Proposal Request

AWSOM

Proposal Request Number: 124

Compactor

1 | L0 - 1/8" DIMENSION PLAN - AREA B
1/8" = 1'-0"

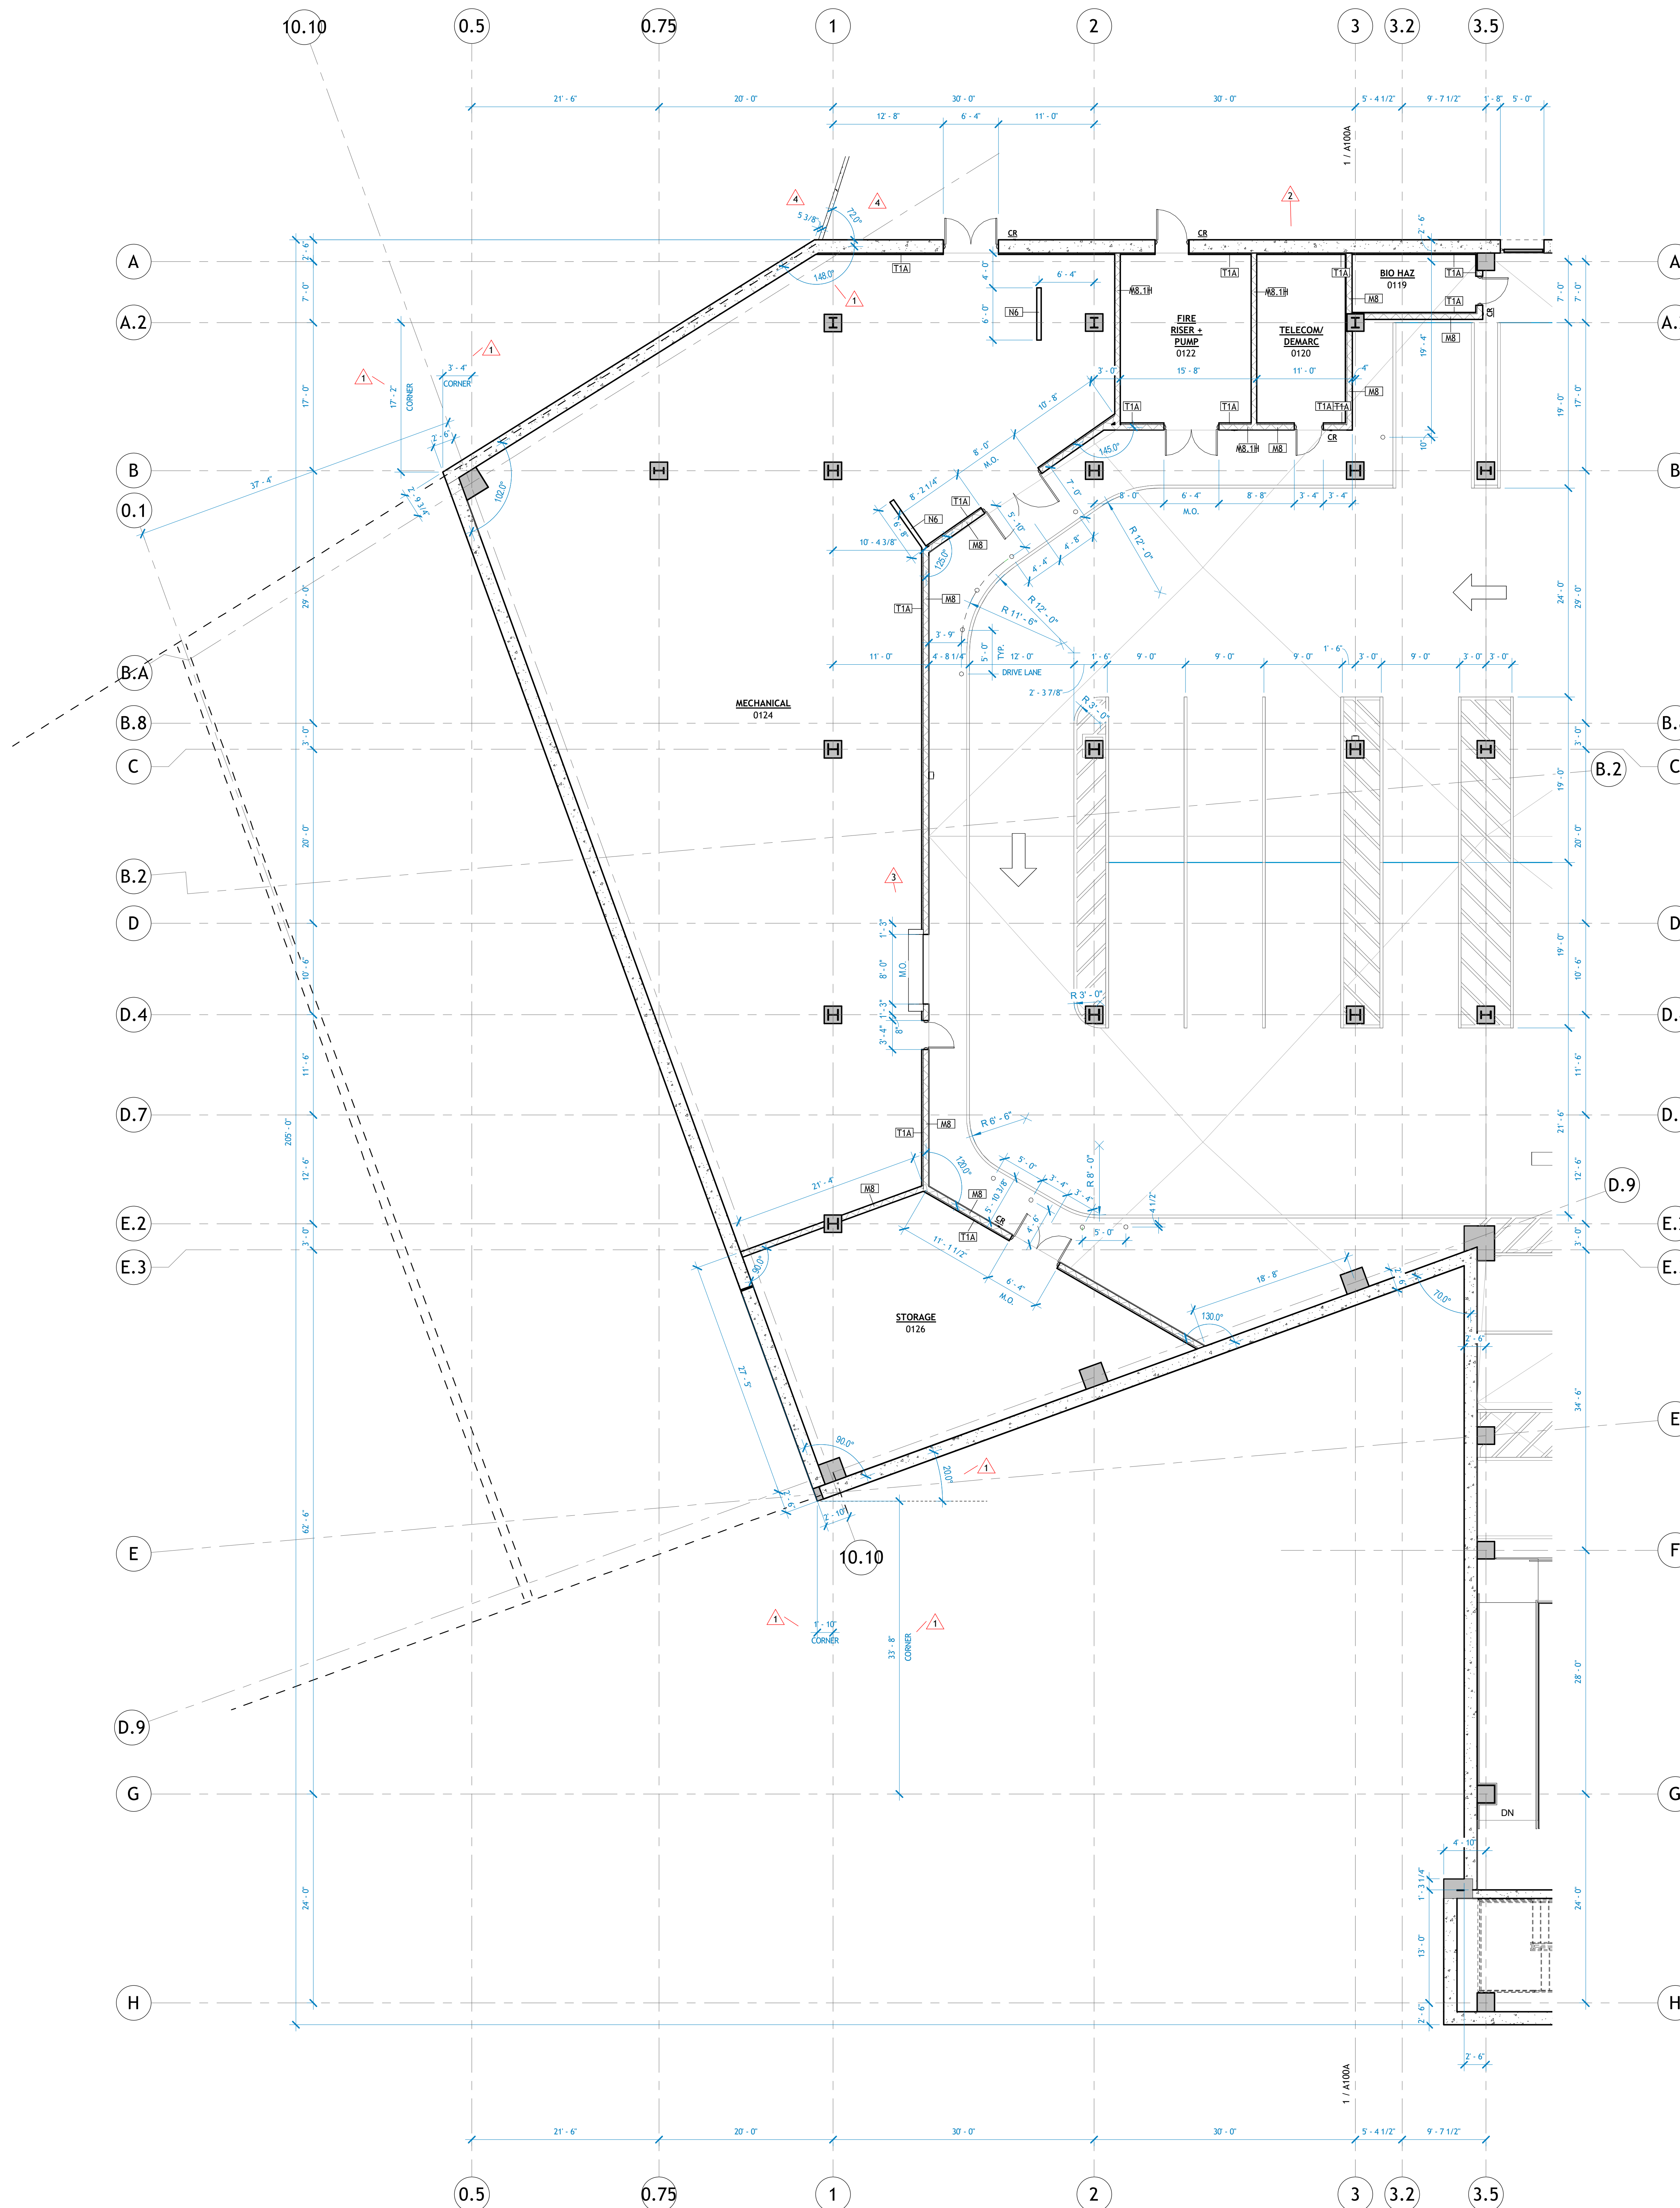
- a) Revised Sheet **A100B**, original issue date 02.24.2023 and revised date 04.18.2025.
 - Detail 2
 - (1) Revise Compactor area to single 30 yd unit.
 - (2) Add callouts at Mech Yard Man Gate
- b) Revised Sheet **A100BD**, original issue date 02.24.2023 and revised date 04.18.2025.
 - Add Details 5 and 6. Elevation and Plan at Yard Man Gate

② EQUIPMENT CONNECTION - LEVEL 0 PLAN - SERVICE YARD
1/8" = 1'-0"

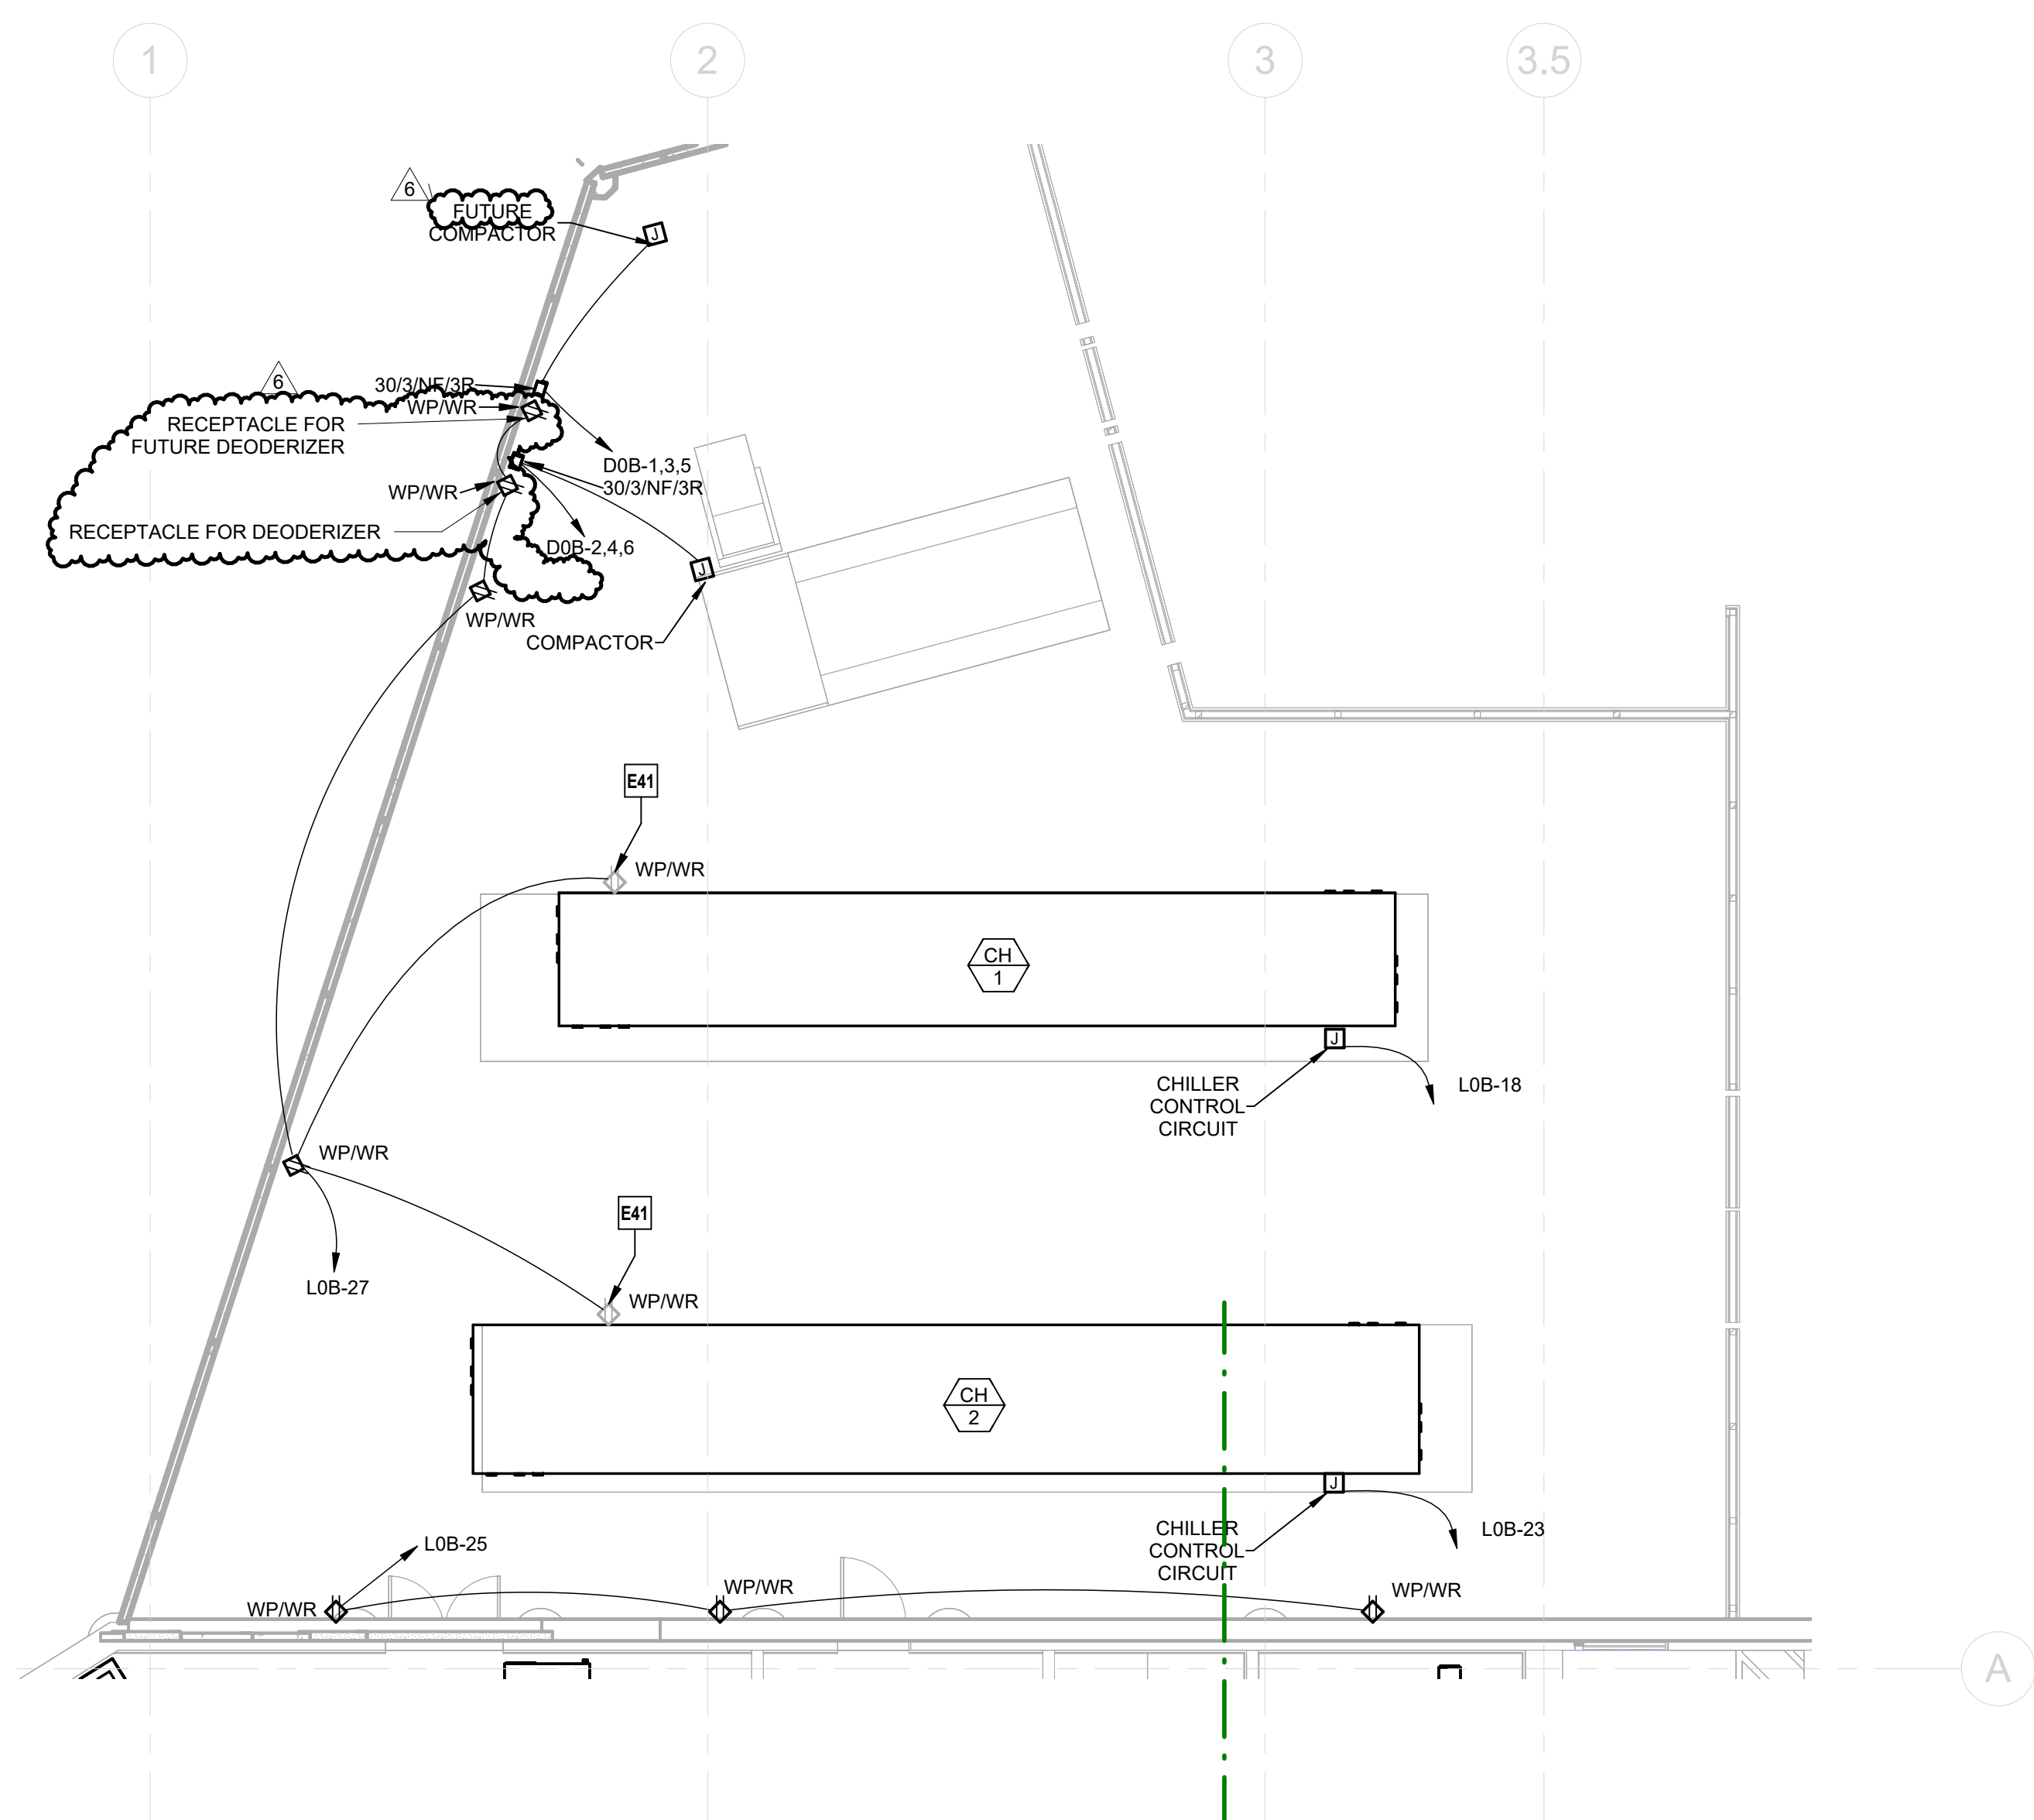
- a) Revised Sheet **E300B**, Detail 2, with original issue date 02.24.2023 and revised date 04.18.2025.
 - Add two receptacles for compactor deodorizers. Circuit to adjacent maintenance receptacle circuit.
- b) Revised Sheet **E907**, with original issue date 02.24.2023 and revised date 04.18.2025.
 - Panelboard L0B: update circuit loads.
